Office Action Summary

09/398,652

SAMARAS ET AL.

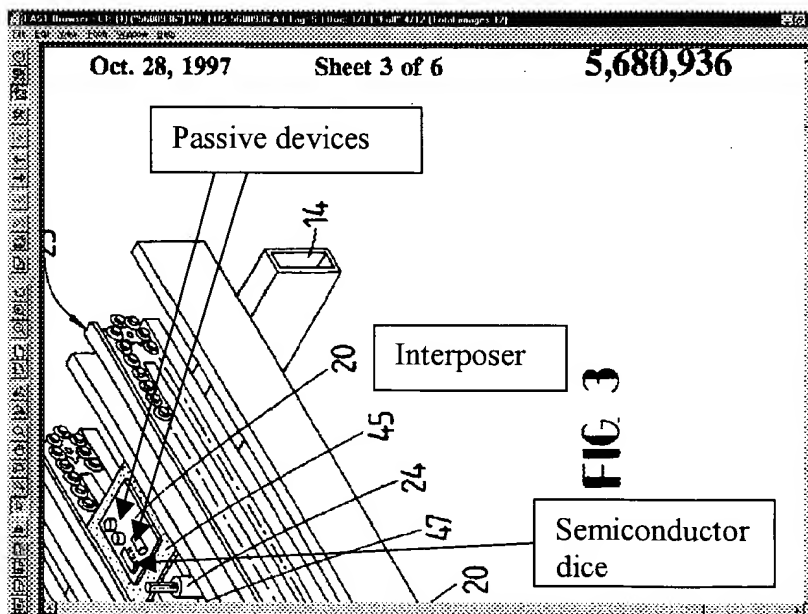
Beers discloses coupling at least one passive device (see annotated Fig. 3 below) thereby regulating voltage and current to the electronic dice.

Furthermore, it would have been obvious to one of ordinary skill in the art at the time the invention was made to modify Seidel by coupling at least one passive device to the first surface of the interposer, as taught by Beers, for the purpose of regulating voltage and current to the electronic chip.
